MIL-S-19500/321A
AMENDMENT 4
30 June 1992
SUPERSEDING
AMENDMENT 3
19 SEPTEMBER 1978

MILITARY SPECIFICATION

SEMICONDUCTOR DEVICE, DIODE, SILICON, MIXER
TYPES 1N21WG, 1N21WGM, AND 1N21WGMR

FIGURE 1. Semiconductor device, diode, types 1N21WG, 1N21WGM, and 1N21WGMR.

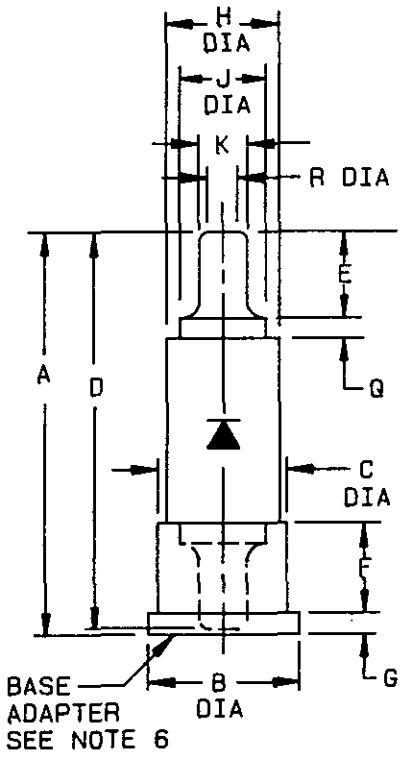
TABLE II, Subgroup 1, details column, second parenthetical statement: Delete "Dim. N, and M and".
